City of Warrenton

Wastewater Treatment Facilities

REQUEST FOR INTERIM CAPACITY INCREASE

Edited responding to:

PUMP STATION REFERENCE MAP

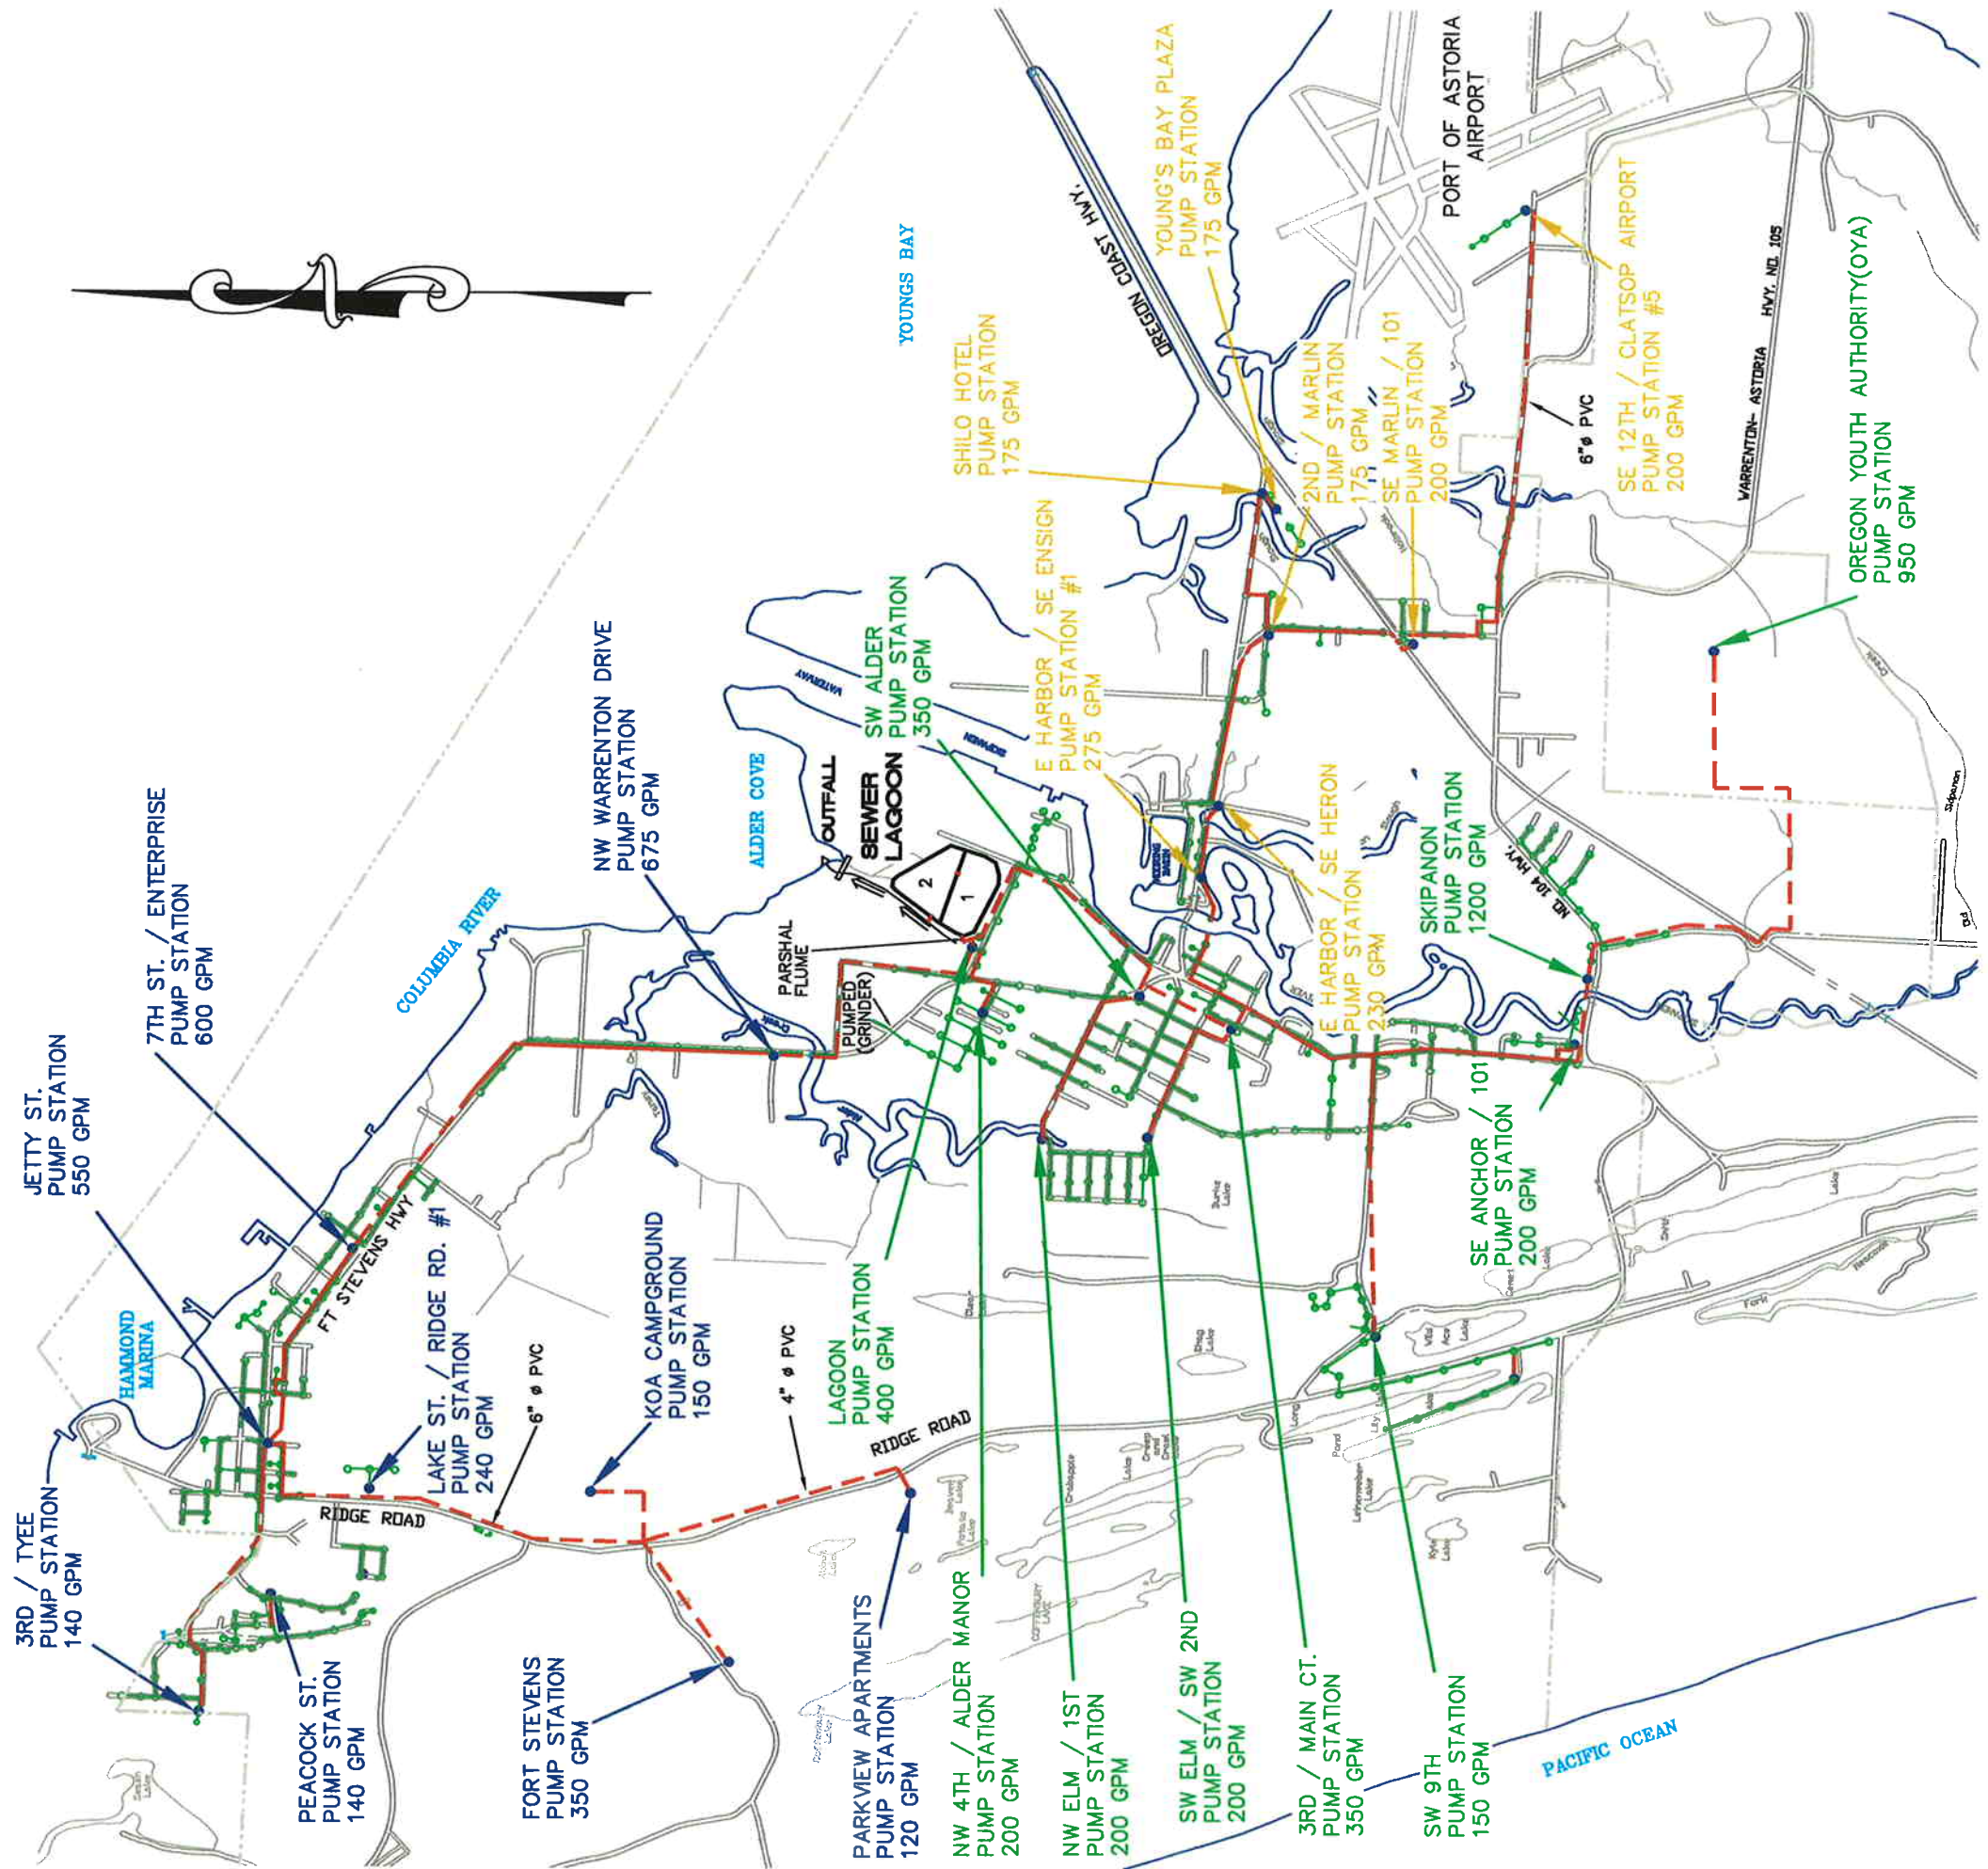
Pump Station Reference Map does not show force mains correctly. Should be like Figure 4.1 in Appendix N.
